PIC16F630/676 Rev. A Silicon/Data Sheet Errata

The PIC16F630/676 parts you have received conform functionally to the Device Data Sheet (DS40039E), except for the anomalies described below.

Clarifications/Corrections to the Data Sheet:

4. Module: New 4x4 QFN Package Added

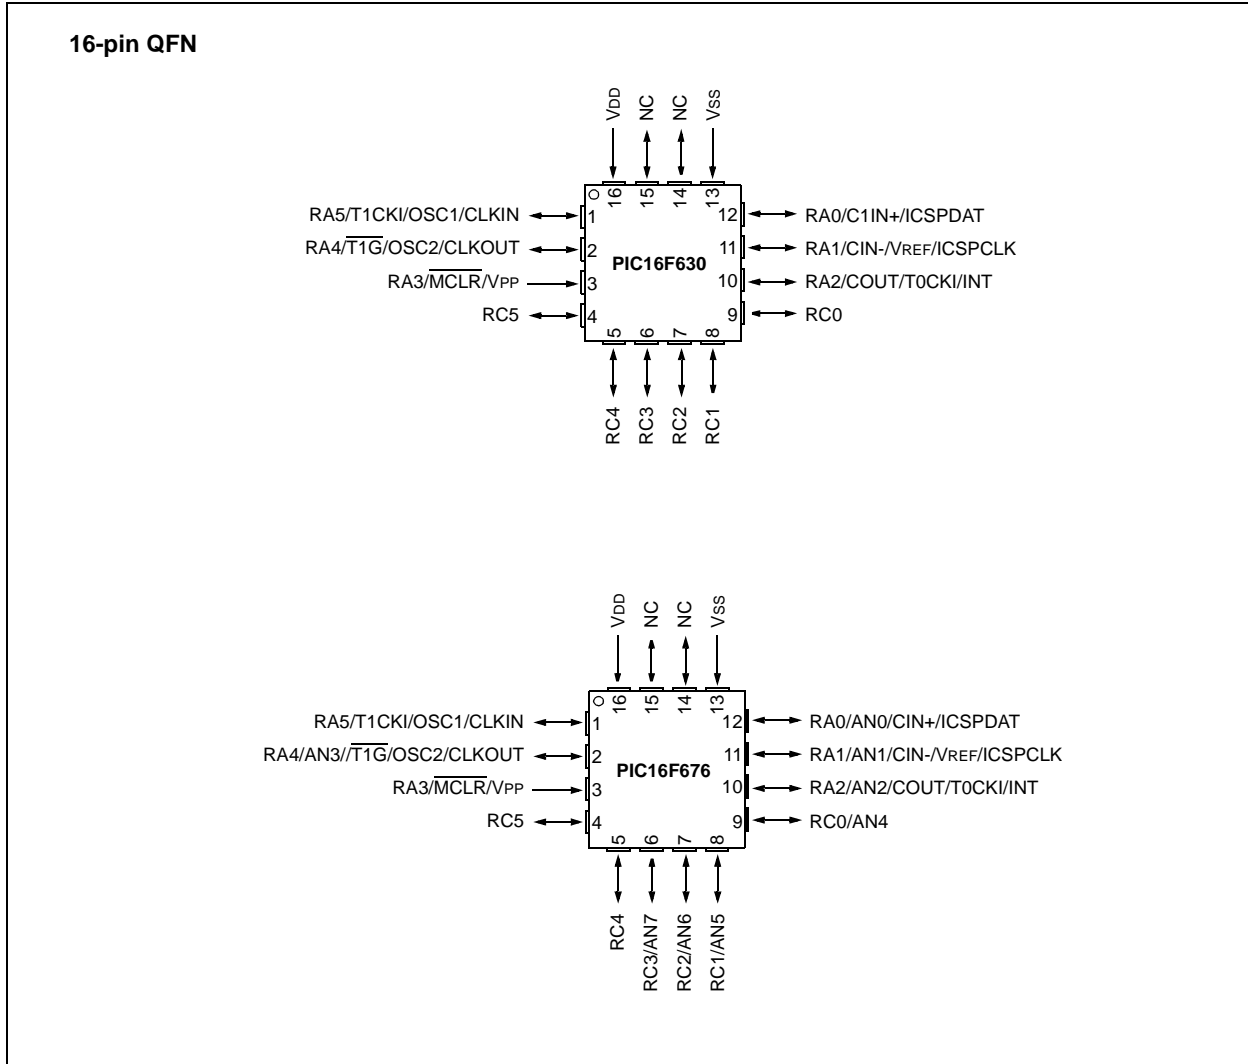
The new 16-pin 4x4 QFN pinout diagrams will be added to the Pin Diagrams figure on page 2 and the Packaging Information chapter as shown below:
